UNITED STATES PATENT AND TRADEMARK OFFICE

APPLICATION NO.	FILING DATE	FIRST NAMED INVENTOR	ATTORNEY DOCKET NO.	CONFIRMATION NO.
10/544,285	08/03/2005	Wolfgang Kentner	2003P00255WOUS	1328

Office Action Summary	Application No. 10/544,285	Applicant(s) KENTNER ET AL.	
	Examiner JOSEPH CORRIGAN	Art Unit 3744

DETAILED ACTION

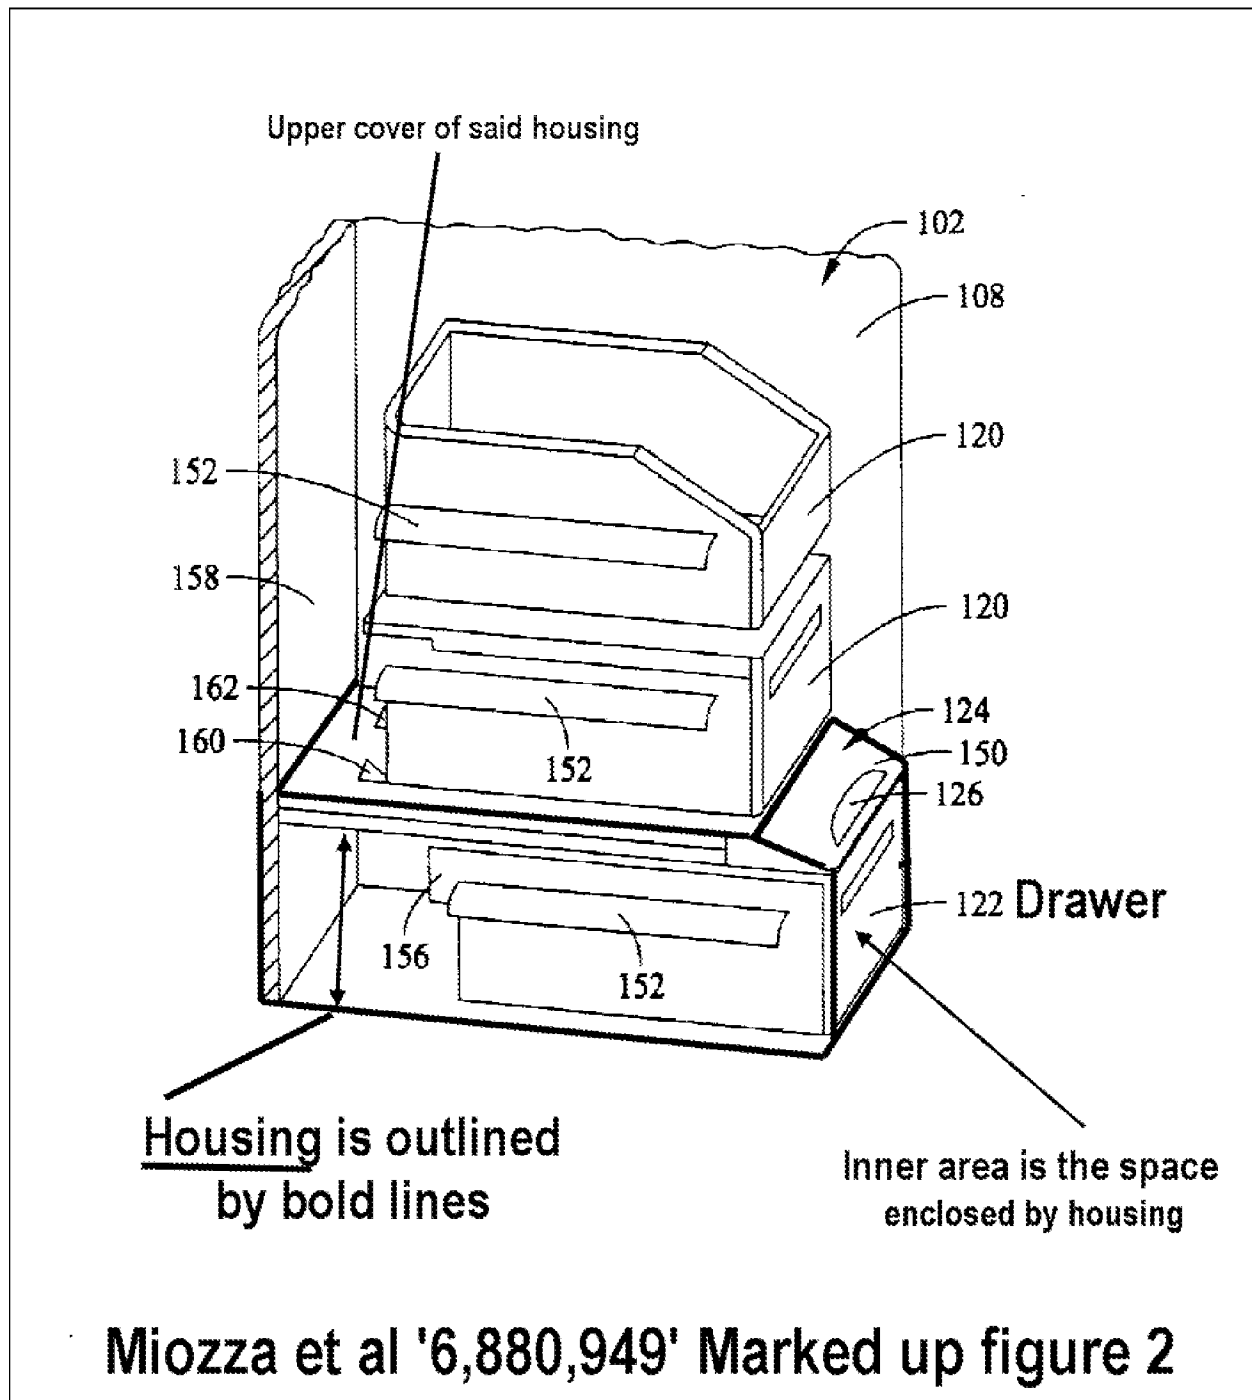
In re claim 14, Miozza et al disclose a refrigeration appliance, comprising: a housing (see marked up figure 2); said housing enclosing an inner area (122, figure 2); said inner area enclosed by a door (136, figure 1); a carrier module (figure 7) located in said housing (see marked up figure 2); and said carrier module including a control circuit (174, figure 3) for controlling (via 172, figure 3) the refrigerating capacity of the refrigeration appliance (figure 1) in said inner area (122, air space within pan, figure 2) depending on a temperature measuring signal (see temperature sensors recited in C4, L21) related to the temperature in said inner area (122, air space within) (see C8, L28-

38 re controlling drawer temperature), at least one operating element (264 temp selector, C8, L47) for at least one of adjusting an operational parameter (temperature of drawer) and a display element (176, figure 3) for displaying an operational parameter (temperature settings, C6, L18-20) of said refrigeration appliance (figure 1) and at least one illuminating agent (206, figure 7) for illuminating at least some of said inner area (see light 206 positioning in figure 6 which shines in drawer).

In re claim 15, Miozza et al disclose the invention above and further disclose a compartment (124, C7, L10) for said carrier module (figures 6-8, C9, L40-47) formed in an upper cover (see marked up figure 2) of said housing (see marked up figure 2).

In re claim 16, Miozza et al disclose invention above and further disclose said cover (210) designed as a side plate (see figure 2, upper cover portion) forming the upper portion of the housing exterior (see marked up figure 2).

In re claim 27, Miozza et al disclose the invention above and further disclose a refrigeration appliance, comprising: a housing (see marked up figure 2); said housing enclosing an inner area (122, space within); said inner area enclosed by a door (136); a compartment formed in an upper cover of said housing, and a carrier module (figure 6) located in said housing compartment (see marked up figures 2); and said carrier module including a control circuit (174, figure 3) for controlling (via 172, figure 3) the
